**AGENDA**  
**Historic Yorktown Design Committee**

**SUBJECT:** Application No. HYDC-276-25, Jeffrey Vance, 114 Ballard Street:  
Amendment to HYDC-263-24, request to clear stain backyard fence

**SUBJECT:** Application No. HYDC-277-25, County of York, Replace all doors, 331 Water Street

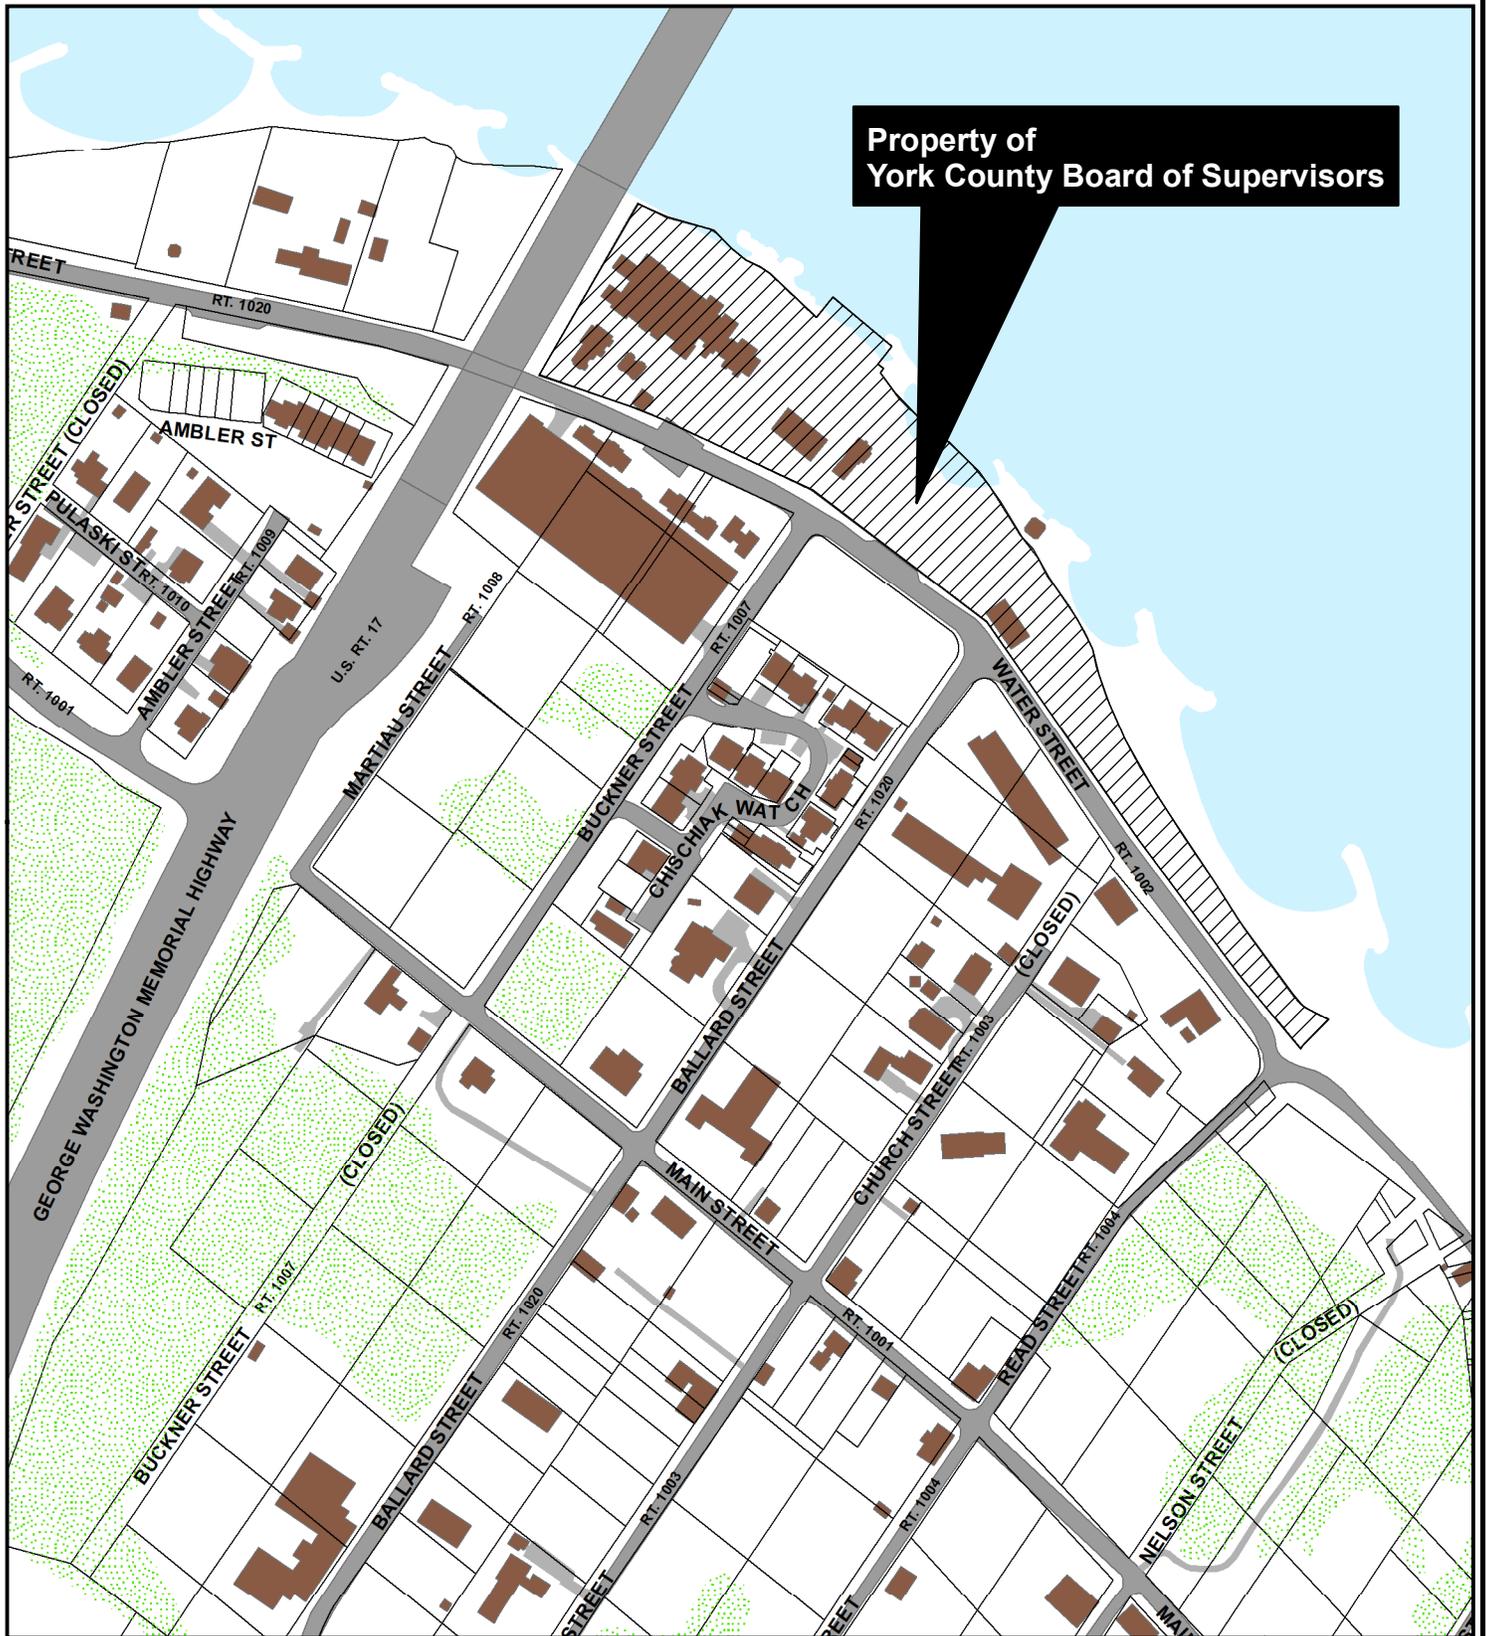
<p><b>C. Architectural Additions, Alterations and New Construction</b></p> <p><b>2. Architectural Elements</b></p> <p>c. Doors</p> <p>(1) Windows in entrance doors are permitted and should be vertically proportioned. Exterior doors should be of painted wood, enameled metal, or glass. Sliding glass doors should not be used.</p>	<p>The new Freight Shed doors would be vertically proportioned, hinged, and made of glass with an enameled black metal frame.</p>

In the staff's opinion, the proposed doors are generally consistent with the Design Guidelines and the overall look of the Riverwalk. The new doors would address problems with HVAC and maintenance, and improve security, but they would still retain a relatively similar appearance to the existing ones. Staff believes that the proposed doors would be visually appealing and that they merit approval. Accordingly, it is recommended that the Committee find the proposal consistent with the Guidelines and that the application be approved, subject to the following conditions:

1. The new doors shall be installed in accordance with the application materials submitted by the applicant and received by the Planning Division on May 13, June 16, and July 2, 2025, copies of which will remain on file with the Planning Division.
